STAFF RECOMMENDATION 922 Lawrence Avenue June 20, 2018

Application: Demolition-partial; New construction—infill and outbuilding/detached accessory dwelling unit

Description of Project: Application is to remove a non-contributing carport, construct of an addition with a ridge raise, and construction of a detached accessory dwelling unit (DADU).

Figures 3 and 4 show the proposed changes to the window on the right façade.

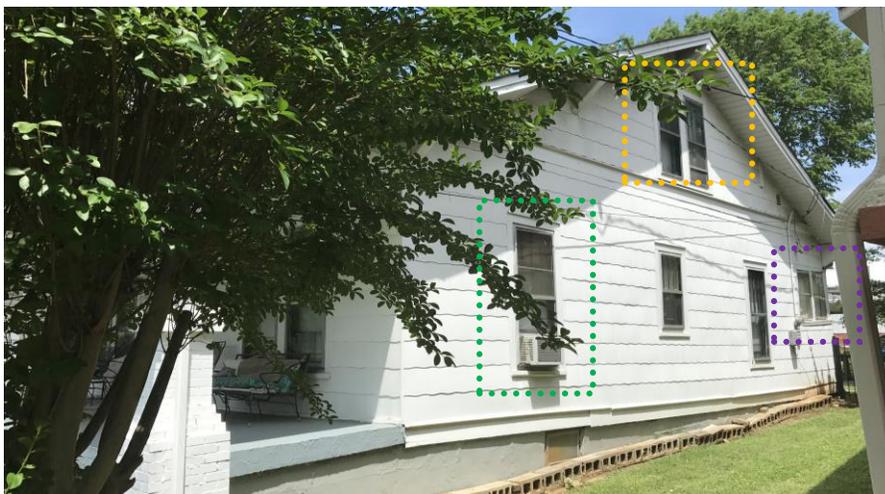
The drawings indicate several changes to the window openings on the side facades of the house, which is considered partial demolition. On the left elevation, the two smaller window openings flanking the chimney area are proposed to be enlarged (Figures 3, 4). Staff finds that the size and scale of these window openings are typical for windows flanking chimneys and are a significant architectural feature. Staff therefore recommends that they remain as-is. The drawings also show the paired attic window as shifted slightly off center, whereas, the existing windows are centered. Staff recommends that these windows remain as is.

The drawings also indicate that the chimney on the left façade is to be removed (See Figures 3 & 4). Staff finds that the chimney is a prominent part of the roof and a significant architectural feature. Staff recommends the retention of the chimney, unless there is proof that it unstable and unable to be repaired.

1. The chimney remain and be repaired, if needed;
2. The window pattern on the side facades remain unchanged, except for the removal of the paired, shorter windows on the ground floor of the right façade;

Figure 6. The DADU's 14' eave.

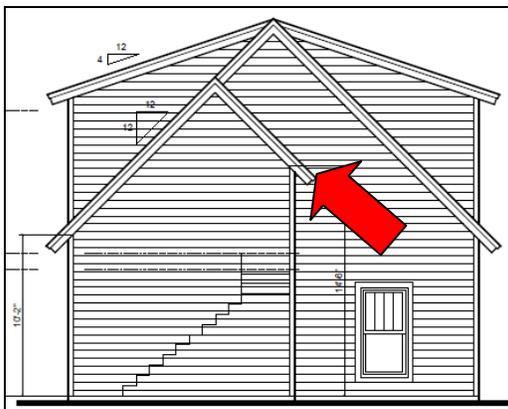
*Most of the DADU's eave lines are less than ten feet (10') in height, but the eave on the stairwell tower portion of the DADU is fourteen feet (14') (Figure 6). Staff recommends approval as the section with the too-tall eave is only approximately three feet (3') wide, a minimal portion of the garage, and the overall footprint is below seven-hundred and fifty square feet.
